Access Compliance Report

Public Rights-of-Way

(Curb Ramps)

Intersection ID: 13197	Main Street: S_MCDOWELL_ST	Cross Street: E_4TH_ST	Location: S
ADA ID: 1DF33C5184F9	Ramp Type: BlendTrans1	Initial Pass/Fail: Fail	Overall Compliance: No
		Severity Score: 12.5

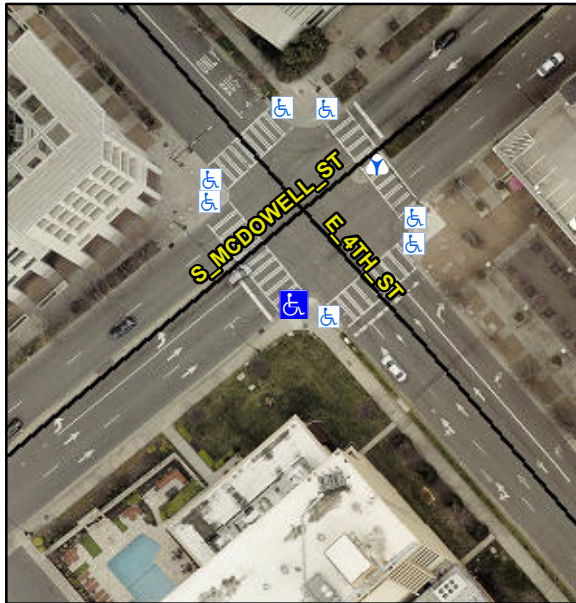
Not Found, R304.5.3

Compliance	Description	Data	Compliance	Description	Data
N/A	Ramp Length (in)	59.0	Yes	BlendTrans Slope (%)	2.3
Yes	Ramp Width (in)	48.0	No	BlendTrans XSlope (%)	6.7
N/A	Flare Type LT	N/A	N/A	Flare Type RT	N/A
N/A	Flare Slope LT (%)	N/A	N/A	Flare Slope RT (%)	N/A
N/A	Flare Traversable LT?	N/A	N/A	Flare Traversable RT?	N/A
N/A	Landing Length (in)	N/A	N/A	DWS Provided?	N/A
N/A	Landing Width (in)	N/A	N/A	DWS Contrast?	N/A
N/A	Landing Slope (%)	N/A	N/A	DWS Length (in)	N/A
N/A	Landing X Slope (%)	N/A	N/A	DWS Full Width?	N/A
N/A	Landing Curb? (Y/N)	N/A	N/A	DWS Offset (in)	N/A
N/A	Shared Landing?	N/A			
N/A	Gutter Ponding?	N/A	N/A	Gutter Slope (%)	N/A
N/A	Gutter Lip Ht (in)	N/A	N/A	Gutter X Slope (%)	N/A
N/A	Painted X Walk1?	Yes	N/A	Painted X Walk2?	N/A
	X Walk 1 Direction	To NW		X Walk 2 Direction	N/A
	X Walk 1 Width (in)	184.0		X Walk 2 Width (in)	N/A
	X Walk 1 Slope (%)	3.6		X Walk 2 Slope (%)	N/A
	X Walk 1 X Slope (%)	2.6		X Walk 2 X Slope (%)	N/A

N/A	Ramp inside XWalk1?	Yes	N/A	Ramp inside XWalk2?	N/A
	Road Slope (%)	2.6		Clear Space?	N/A
	Road X Slope (%)	3.6	N/A	Clear Space to XWalk (in)	N/A
N/A	Any Obstructions?	N/A	N/A	Storm Grate/Utility Hazard?	N/A
	Obstruction Type			Storm Grate/Utility Type	
		N/A			N/A
			Yes	Surface Condition? (G/P)	Good
			No	Curb Slope (%)	8.2

Remove & Replace Curb Ramp With Two New Directional Ramps or Equivalent.
